Case Number ABP – 321522-24
Scart Mountain Grid Connection
Response to Submissions Report

FuturEnergy Ireland

Document Control Sheet	
Document Reference	Scart Mountain Grid Connection Response to Submissions Report
Client:	FuturEnergy Scart Mountain Designated Activity Company Limited
Project Reference	11303

Figure 1 Updated version of Figure 3-5 in Chapter 3 of the Submitted EIAR (Consideration of Alternatives) to provide clarity on the alternative routes being assessed. Title: Alternatives to the proposed Grid Connection Route

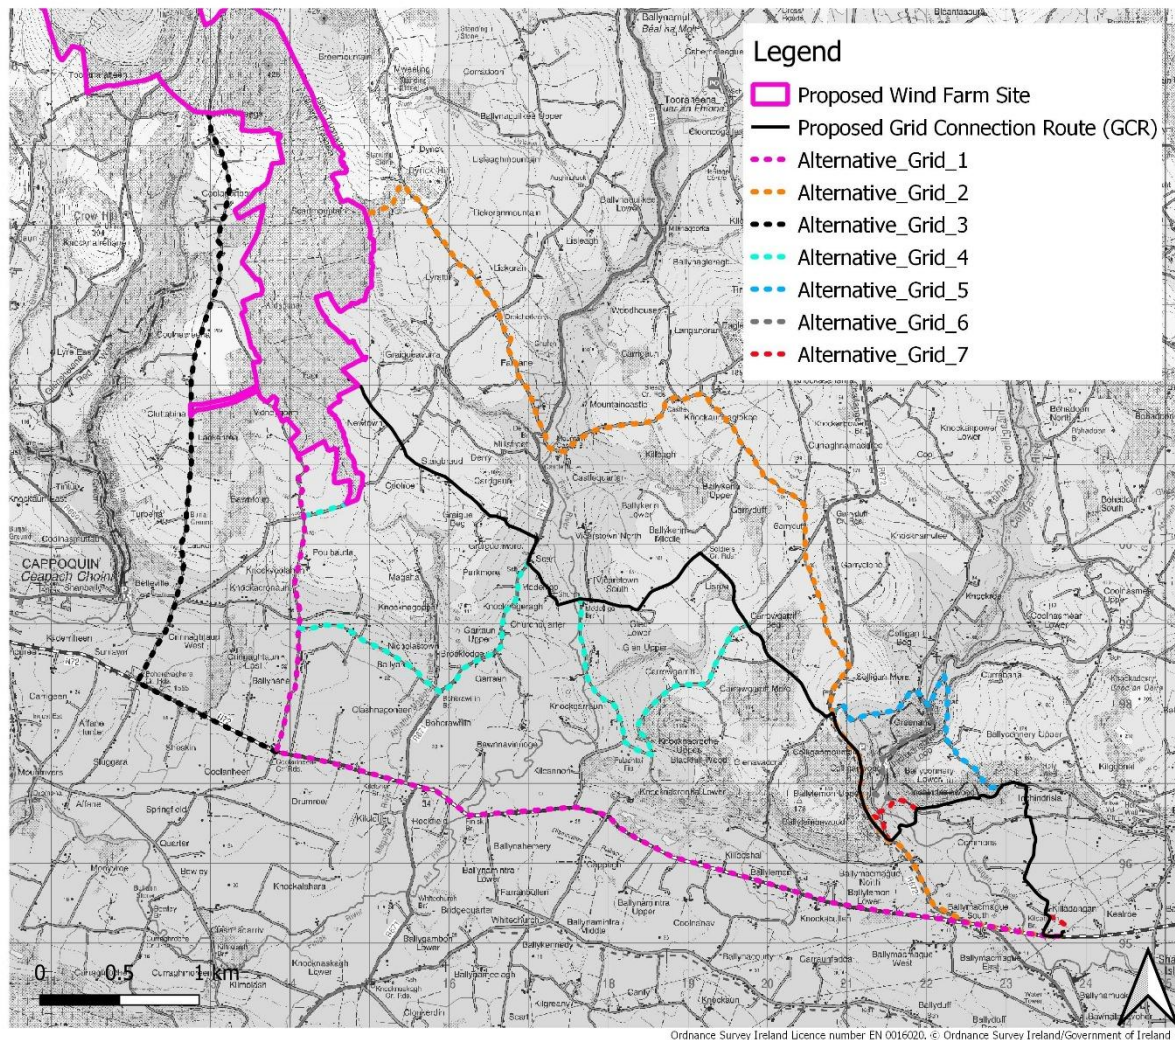
- Alternative grid connection routes mostly via the N72 (see black and pink in Figure 1 below)
- Alternative grid connection routes via local/regional roads from the eastern side of the proposed wind farm site (see orange in Figure 1 below)
- Alternative grid connection routes – short sections (see light blue, grey and dashed red in Figure 1 below)
- Alternative grid connection routes – (see turquoise in Figure 2-1 below)

It should be noted that Figure 3-5 was incorrectly labelled as Figure 3-4 in the EIAR due to a typographical error, and the routes did not all display clearly in the map. They are shown more clearly in Figure 1 below. The findings of the assessment however were unaffected by this issue and they remain valid. The proposed grid connection route is the most appropriate option for the route.

Figure 4 Reproduction of submitted EIAR Figure 8-4 for information purposes – see Figure 8-4 in Chapter 8 of EIAR for full details

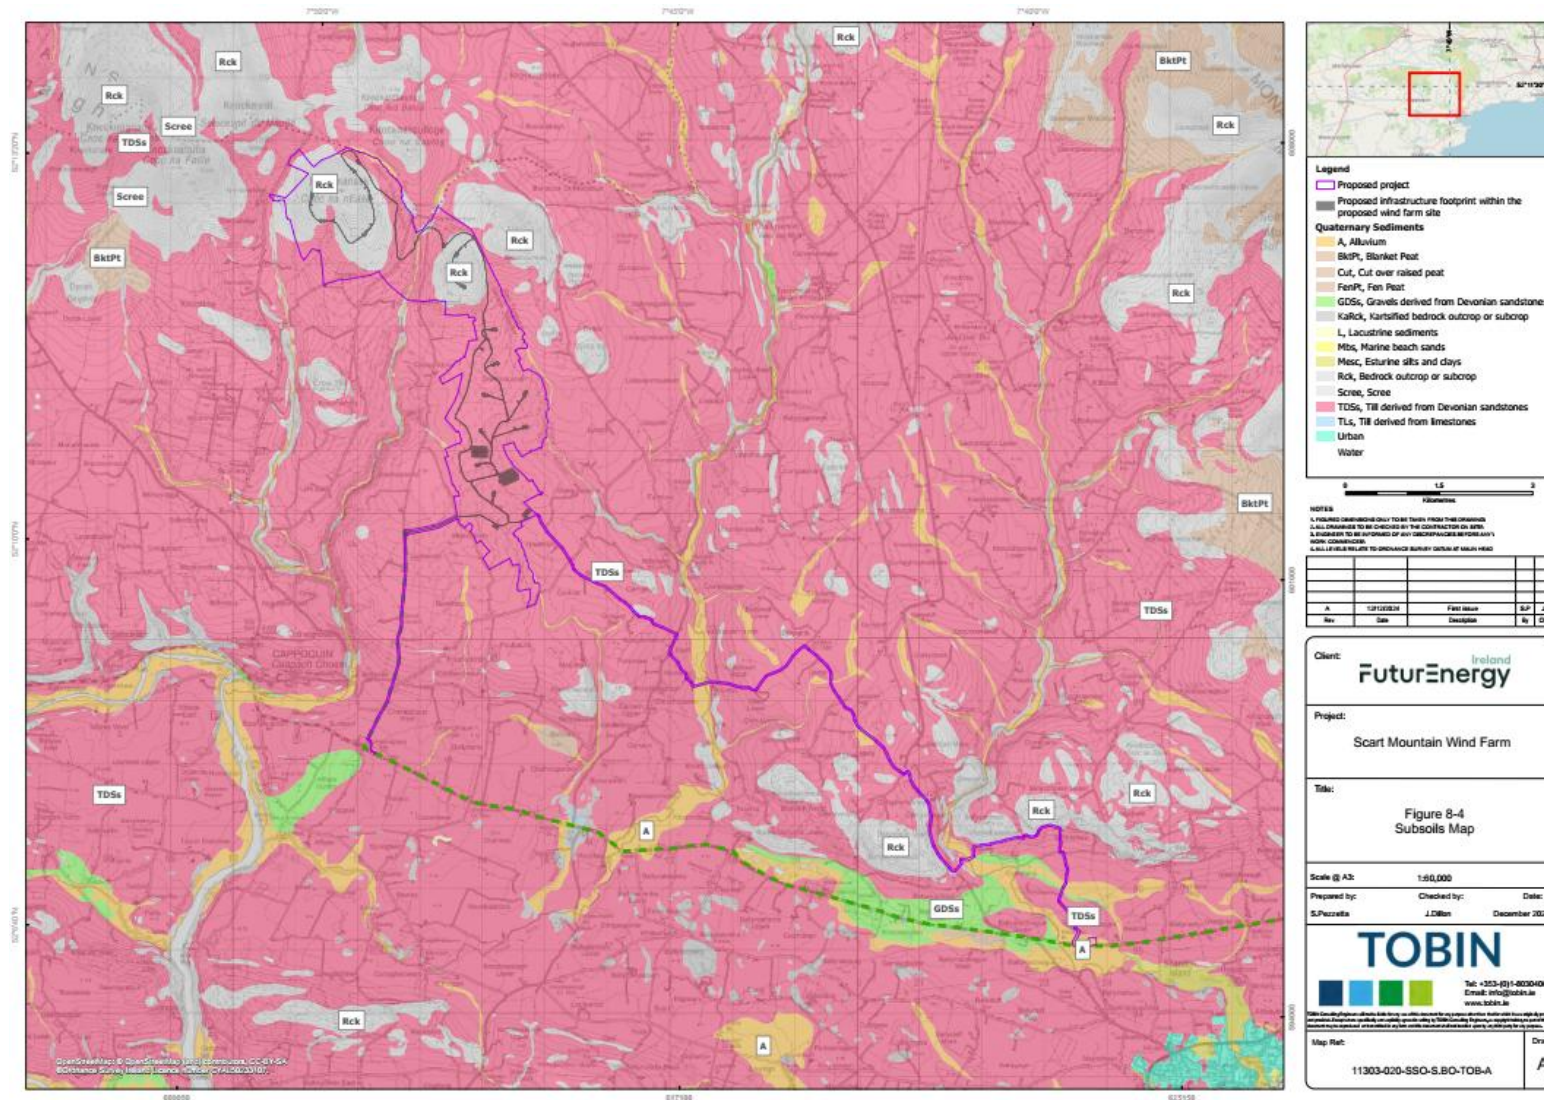
A concern was raised relating to soil stability and peat along the proposed GCR. The proposed GCR is located primarily in public road corridors where there are no known peat soils. As shown in Figure 8-4 (Chapter 8) of the submitted EIAR (reproduced below for convenience of the reader), there are no mapped (by GSI) peat soils located along the GCR and no peat was identified during site visits. Therefore, the concerns raised relating to peat and soil stability are not applicable to the proposed GCR. Figure 8-4 is included below.
